TO: ALL PLANHOLDERS OF RECORD
RE: RFP 26T-CN-203 Baxter Family Housing II – Civil Construction
FROM: Rashaad Esters, Procurement Manager
PAGE(S): 40, including this cover sheet
DATE: April 6, 2026

RFP 26T-CN-203 Baxter Family Housing II – Civil Construction

1. Answer questions submitted by the deadline date of 03/31/2026, 2:00PM
2. Provide an updated Bid Form
3. Provide a revised schedule
4. Provide revised Baxter Phase II Civil Drawings
5. Phase I Water improvements
6. Phase I Sewer improvements

Baxter Family Housing Phase II – Civil Construction
RFP 26T-CN-203
Q&A

VALETSKAYA ADDITION NO. 1 TRACT B GRADING PLAN

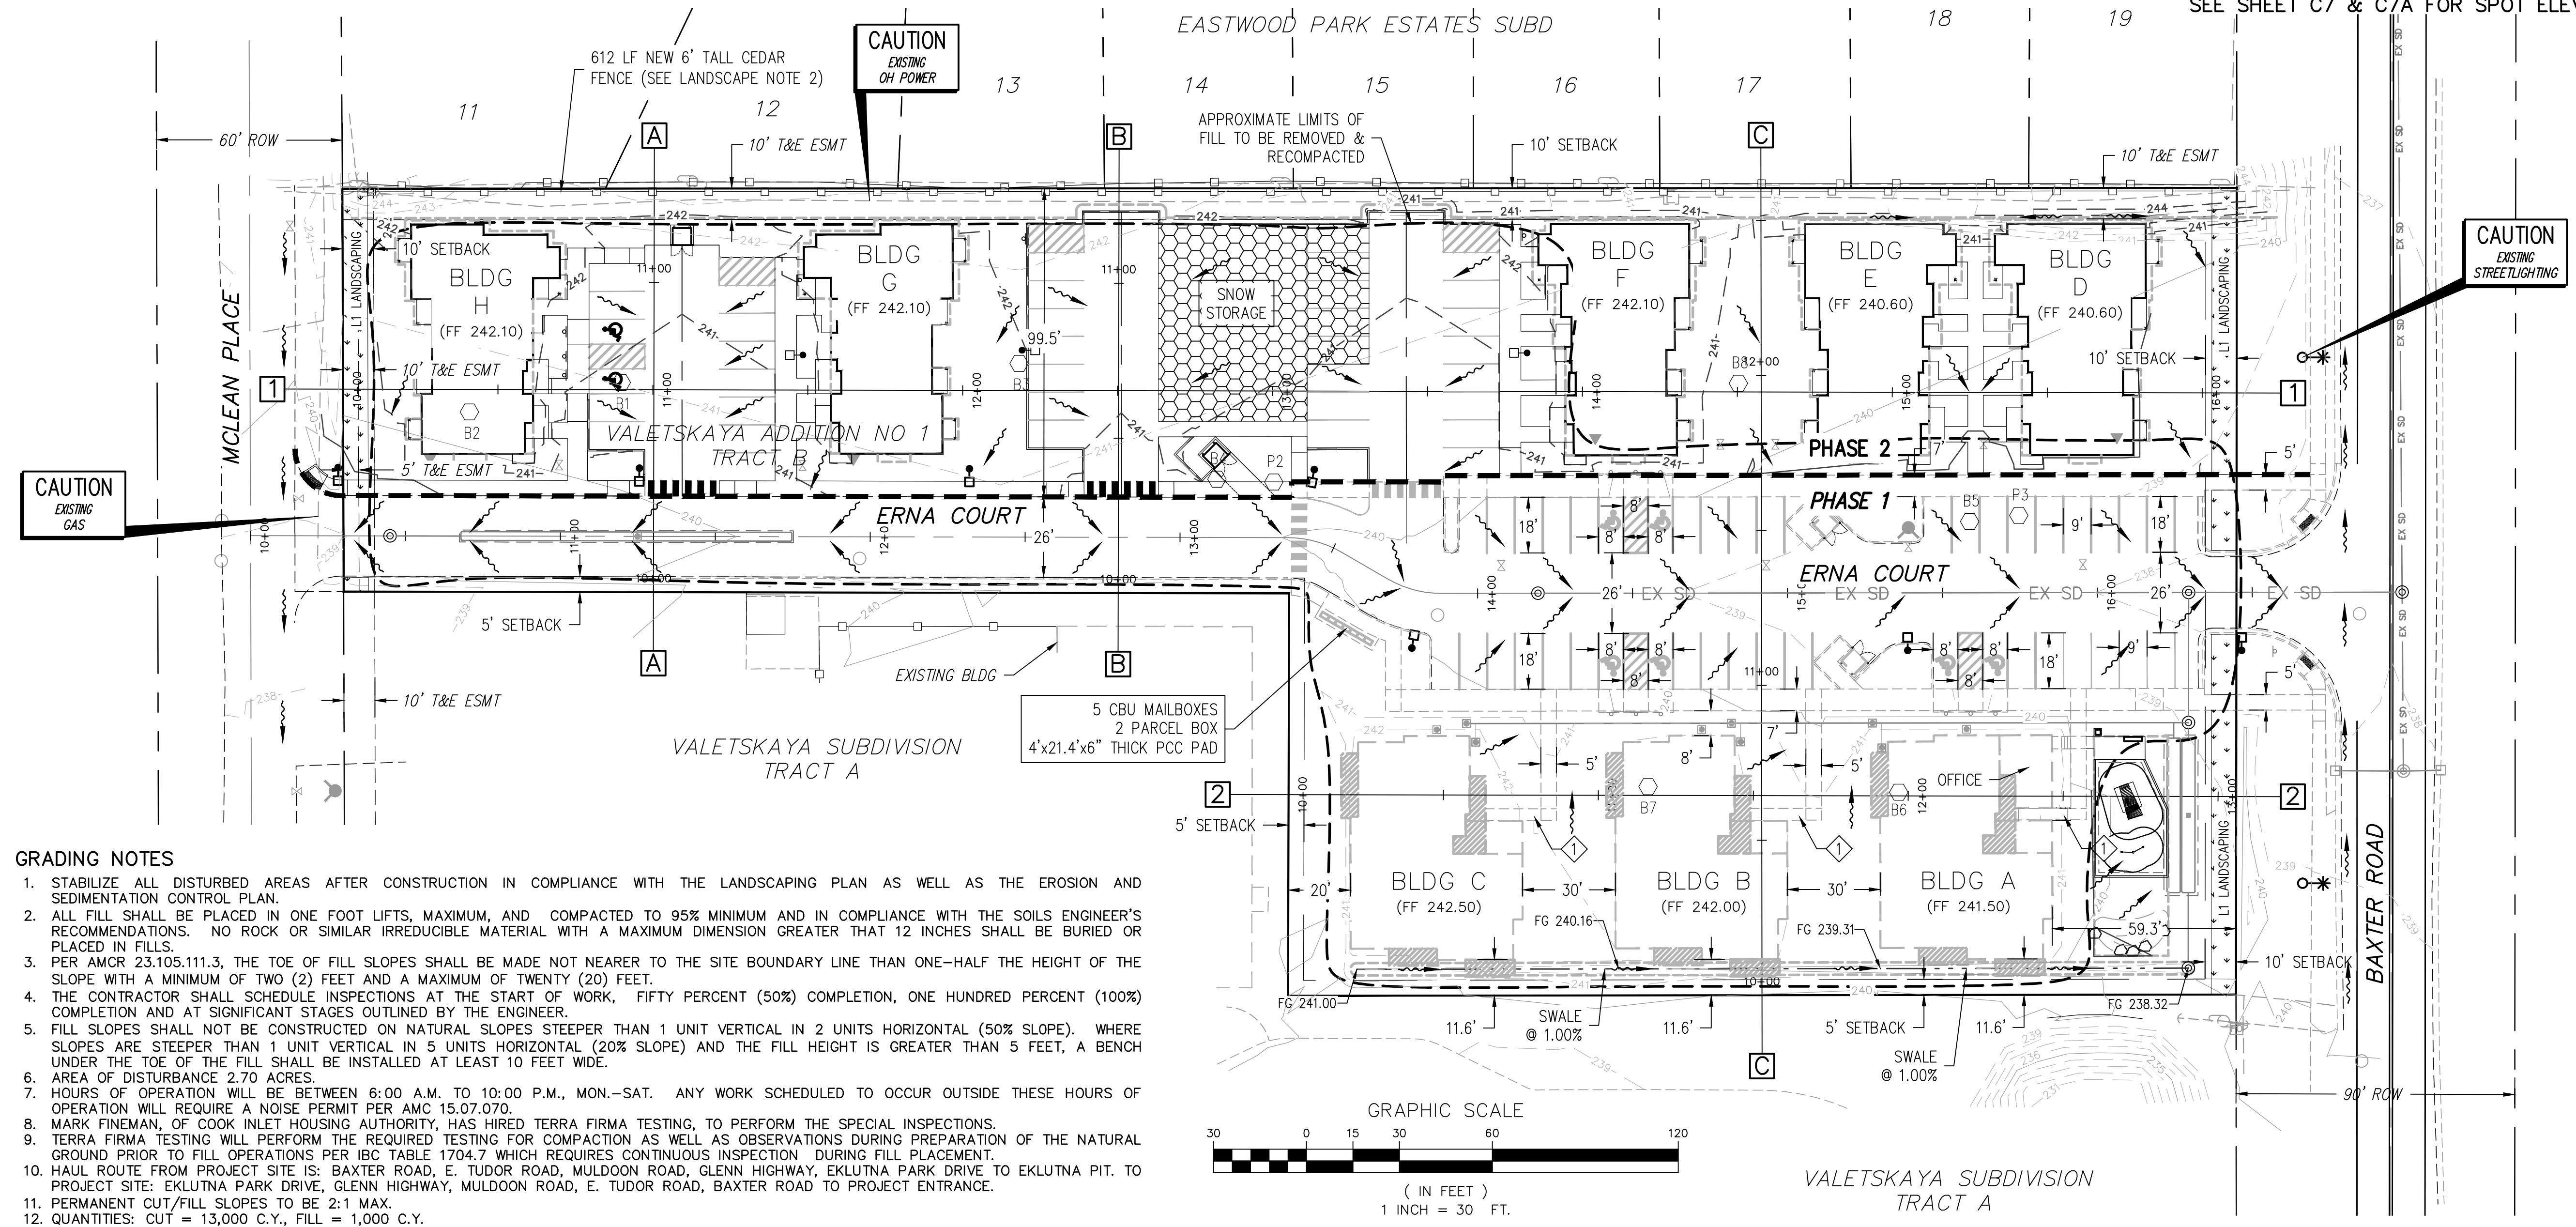
16. Question: Sheet C6 -Note 12 Quantity – Note 12 on Sheet C6 lists a quantity that appears to match Phase 1 civil package quantity. Please confirm whether this quantity was entirely removed/completed by the Phase 1 contractor.	Answer: The existing grades for Phase II scope of work will be very close to the finish grades of Phase II. The Phase II civil contractor will have to remove and haul off the excavation for the building foundations, the sidewalk structural sections as well as the parking lot structural sections.

DESIGNED: B.M. DRAWN: B.M. CHECKED: G.M. FILE: BAXTER MULTI-FAMILY
 JOB NO.: 24-155 CASE: N/A DATE: MAR 2026
 SCALE: HORIZ: 1"=50' VERT: 1"=5'
 SHEET **C8** OF 20

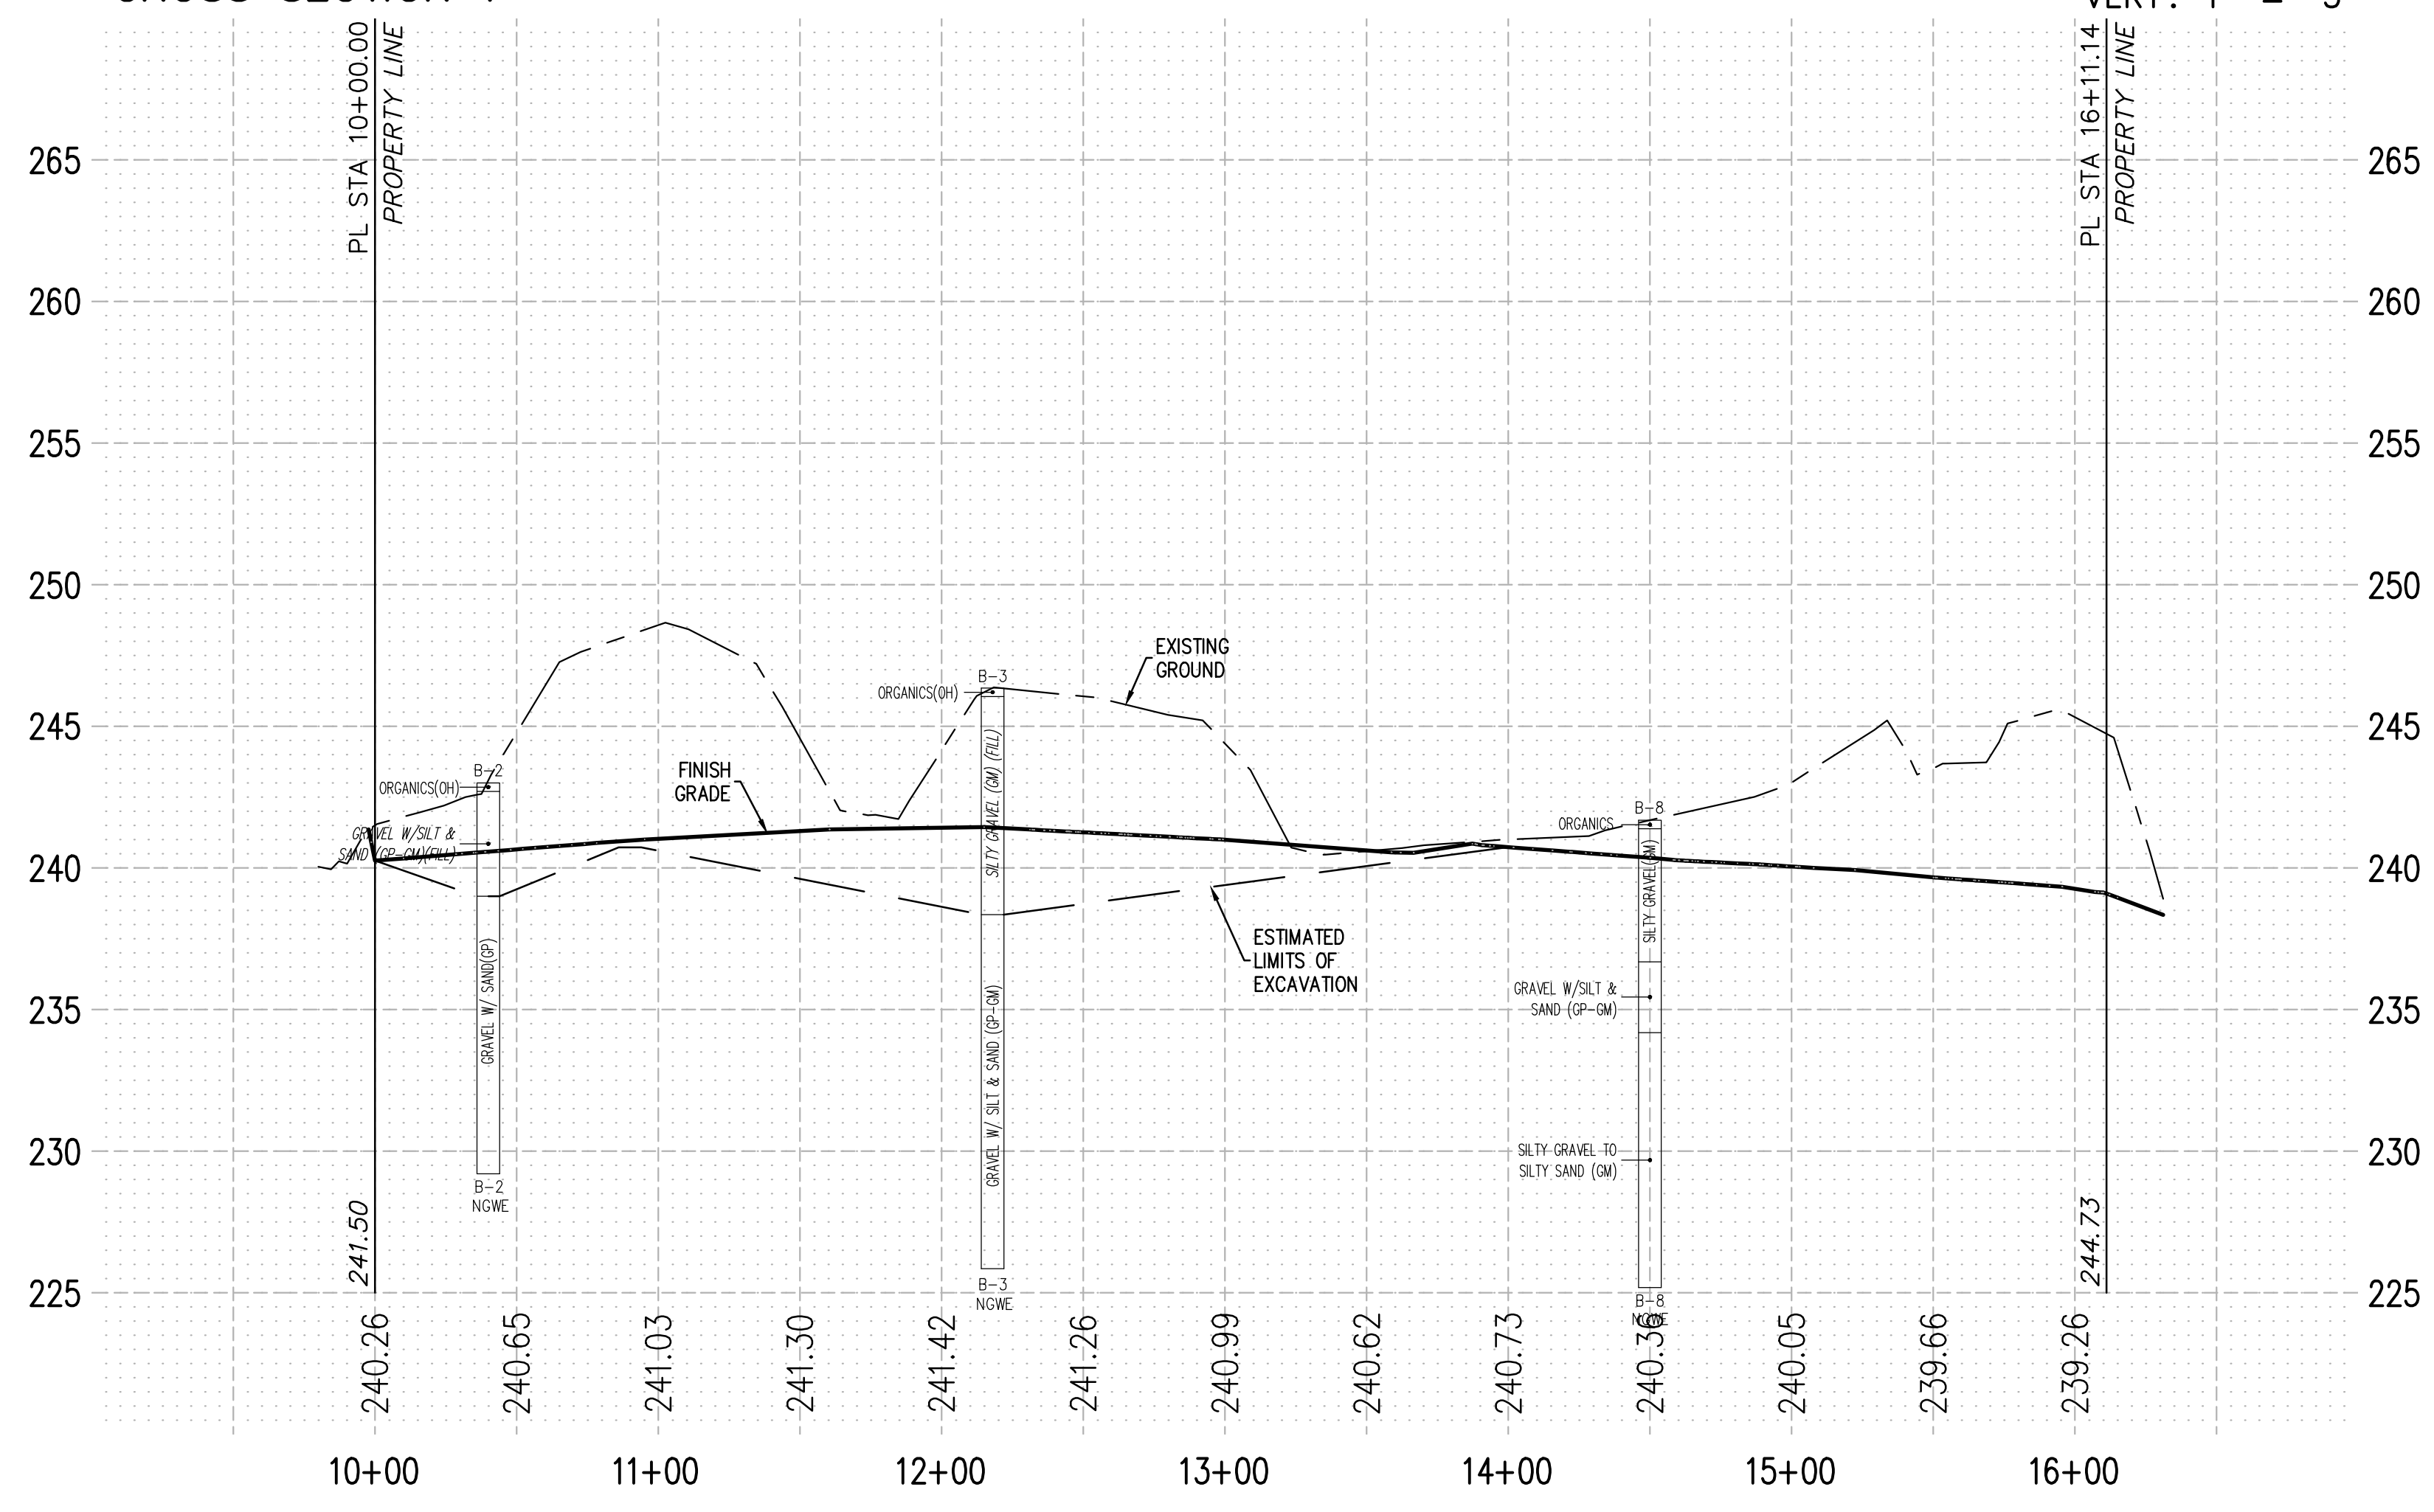
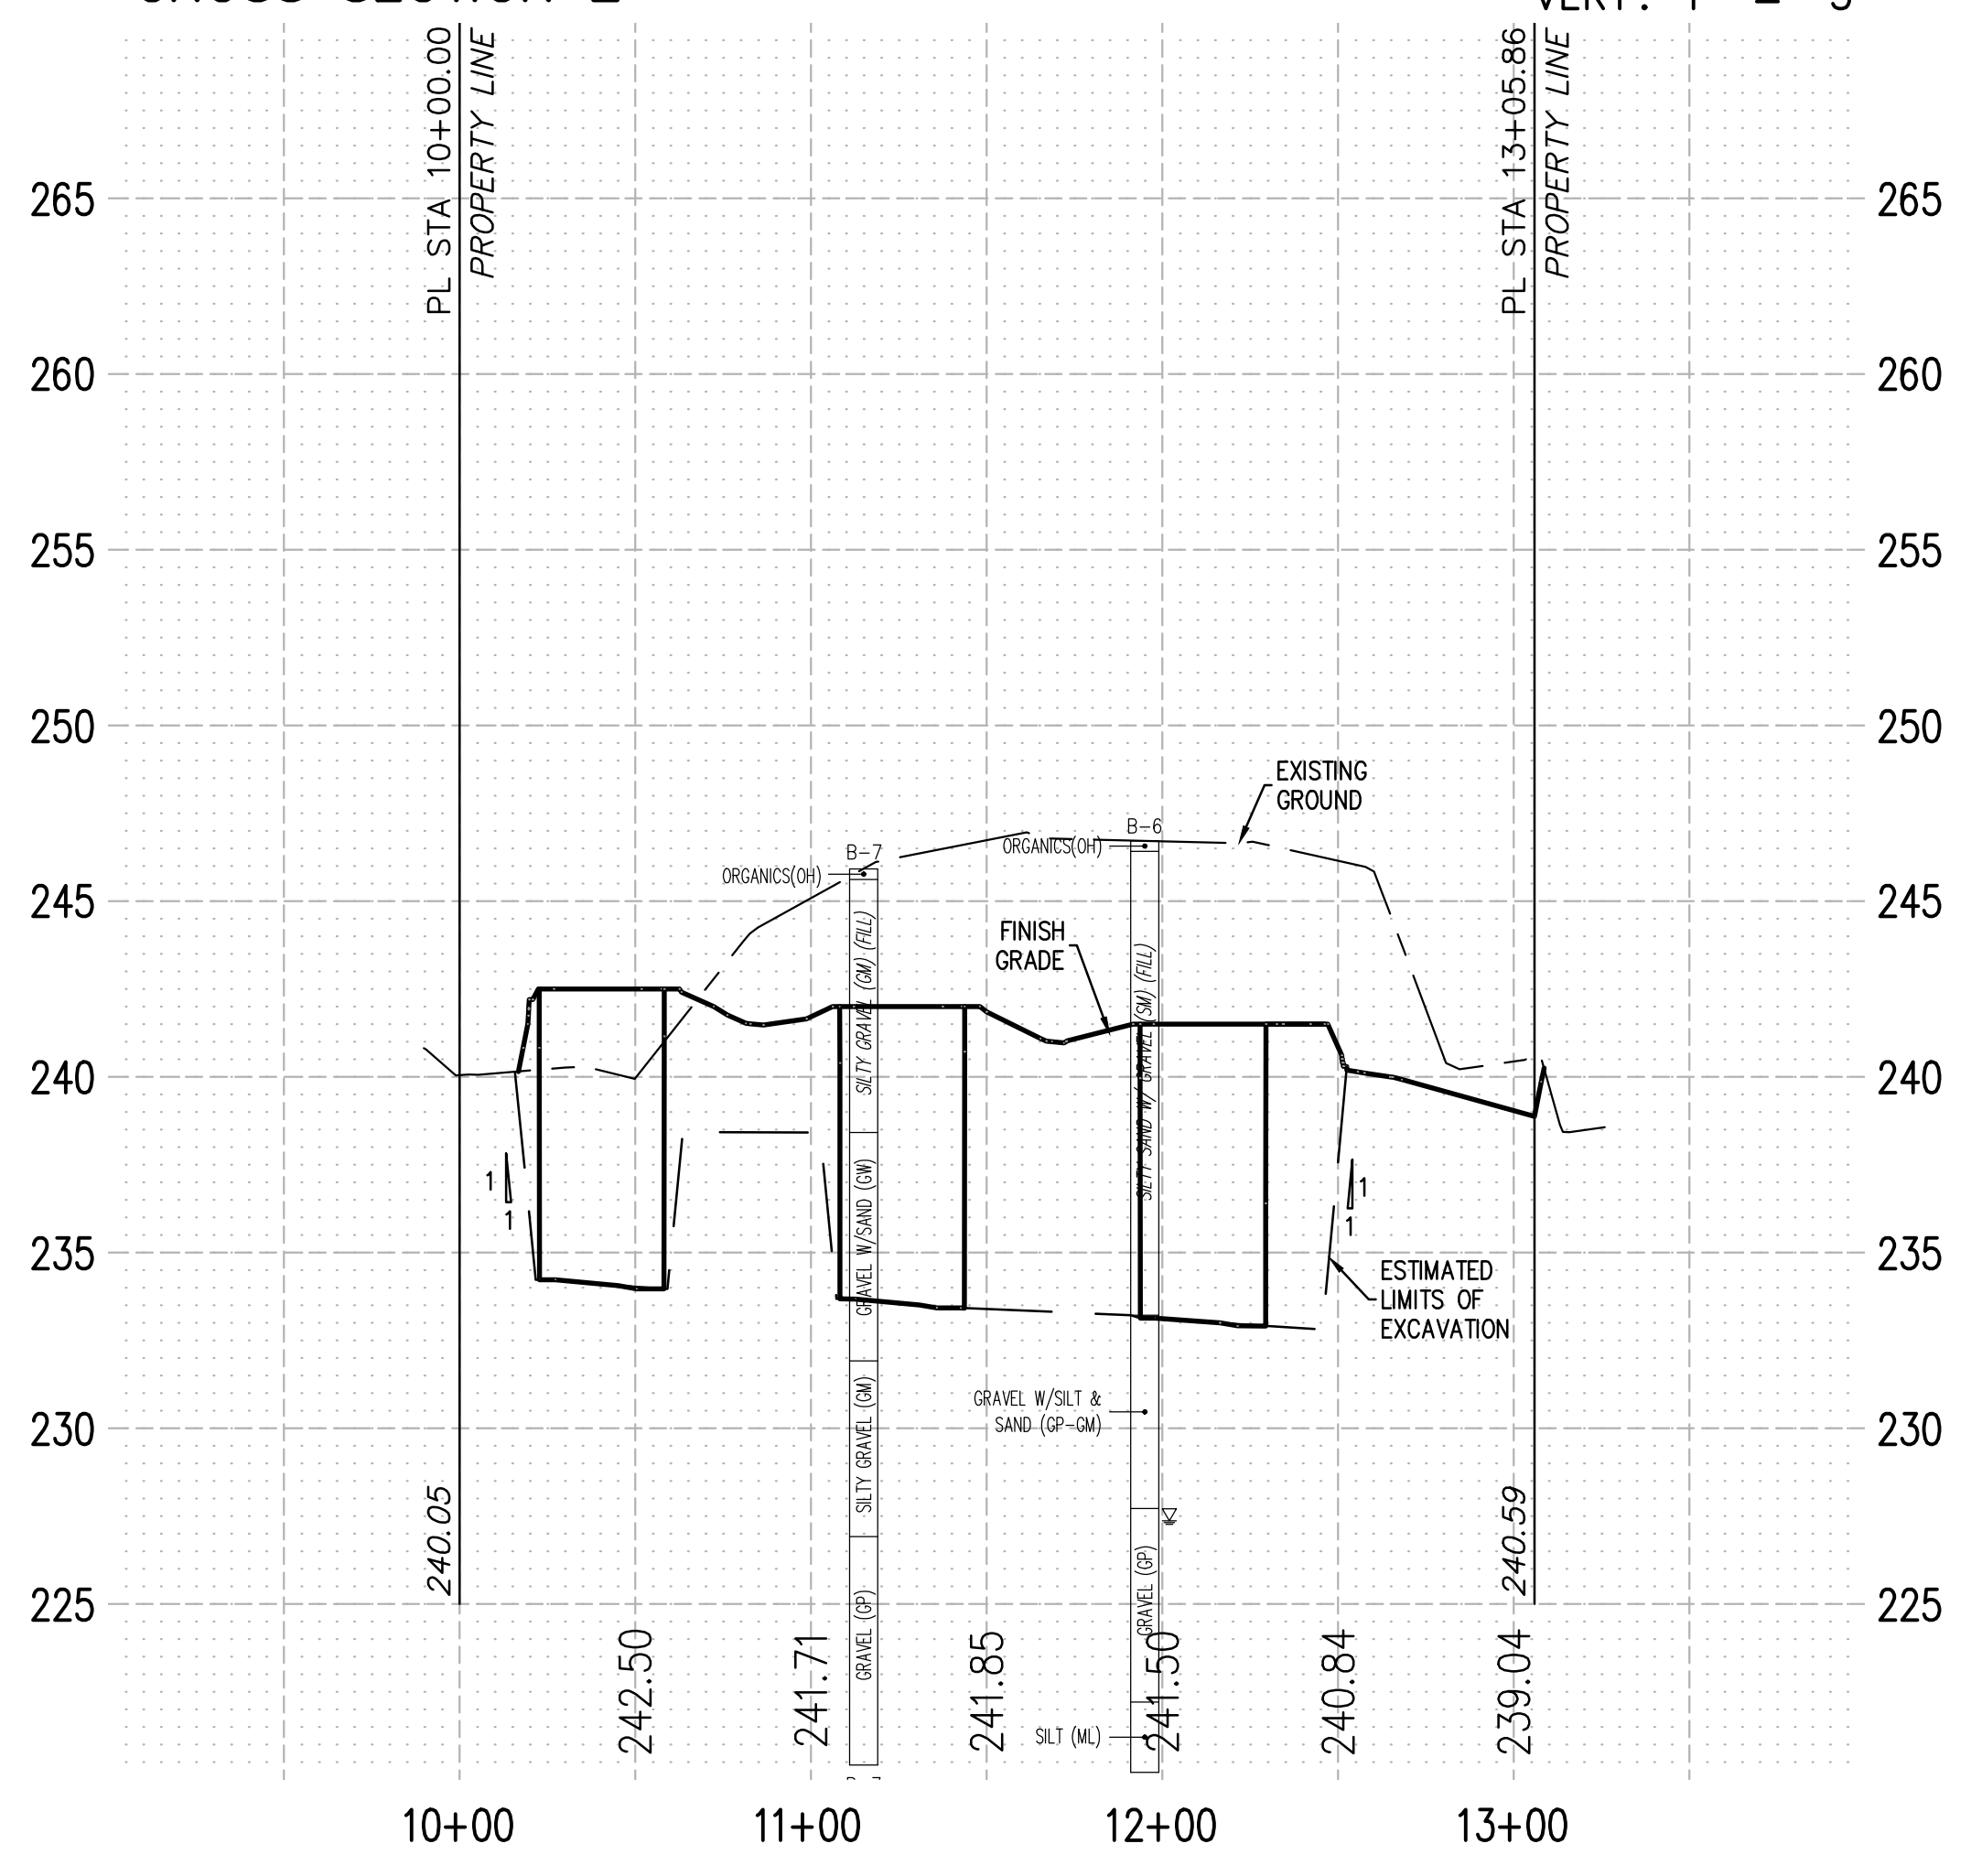
15. Question: Cross Sections – The cross section provided appears to be from the Phase 1 civil package. If this is the case, please provide updated cross sections specific to Phase 2 scope.	Answer: We do not have an updated survey to show new cross section since the Phase I scope of work still needs to be completed this spring/early summer. Phase 2 is a change order to Phase I Master Fill & Grade permit so we still need to show the original conditions for the original permit. See also question and answer #16.
